Road Safety Audit Report

**Incorporating
Stage 1 Completion of Preliminary Design.**

Proposed Access off the A259 New Road, Rustlington

REV	ISSUE PURPOSE	AUTHOR	CHECKED	APPROVED	DATE
1	Stage 1 Road Safety Audit included	JJF	AJB	JJF	8 th April 2015
2	Stage 1 Designer's Response Incorporated	PM	AJB	JJF	21 st May 2015

Photographs from site visit

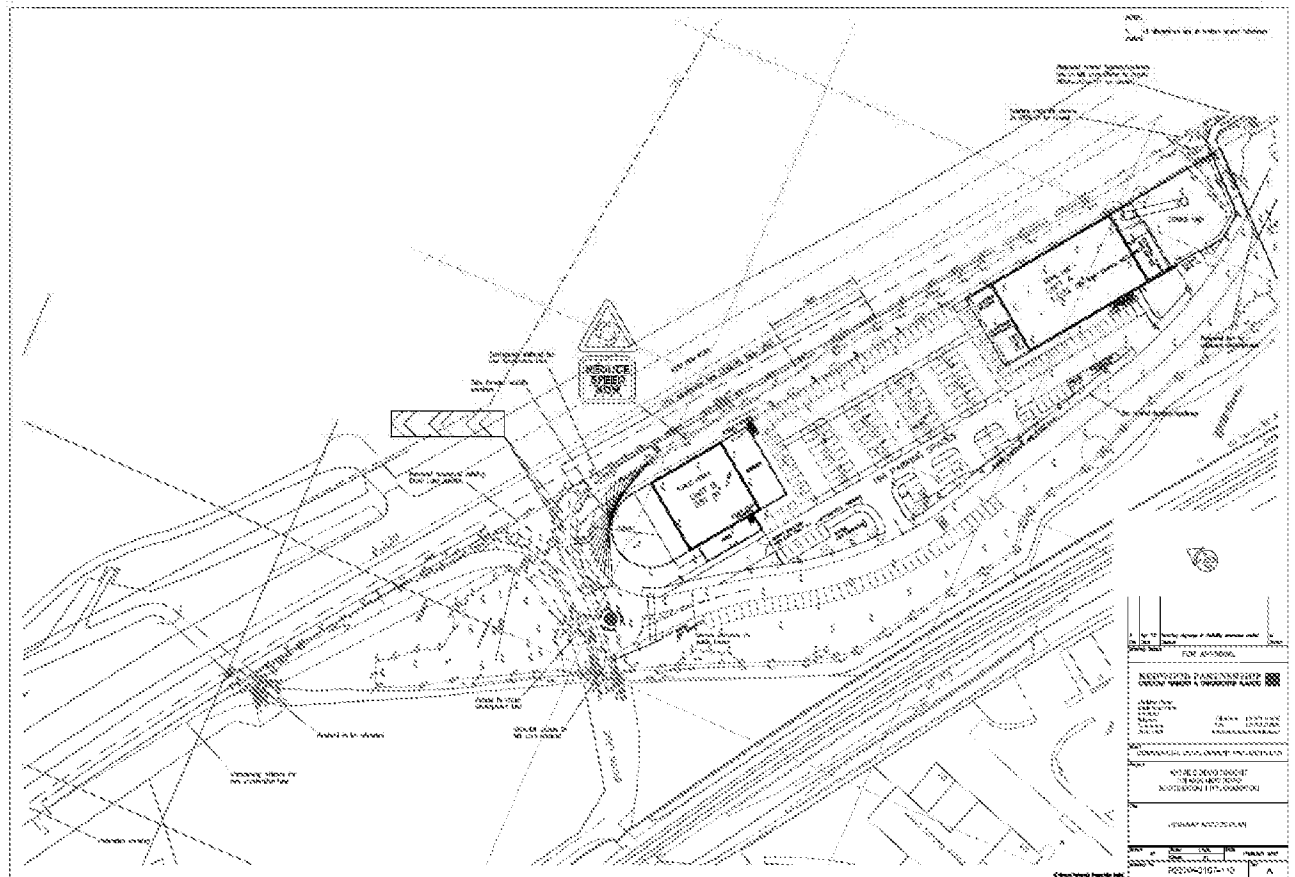
- 1.3 This Road Safety Audit is an assessment of the proposed access improvement and proposed roundabout only and does not include the on-site access road or parking/servicing arrangement.
- 1.4 The site visit associated with this Stage 1 Road Safety Audit commenced during day light at 10am on Monday 6th April 2015. Weather conditions during the site visit were sunny with light wind, the road surface was dry and visibility was clear. Photographs from the site visit are attached at the relevant **Appendix 1**.
- 1.5 No pedestrians were observed during the visit but two cyclists as well as motorised vehicular traffic was observed travelling on the A259 in proximity of the site, speeds were not recorded.
- 1.6 The site visit allowed the team to assess the existing infrastructure in the vicinity of the site and put the proposals in context with conditions on the local highway network.
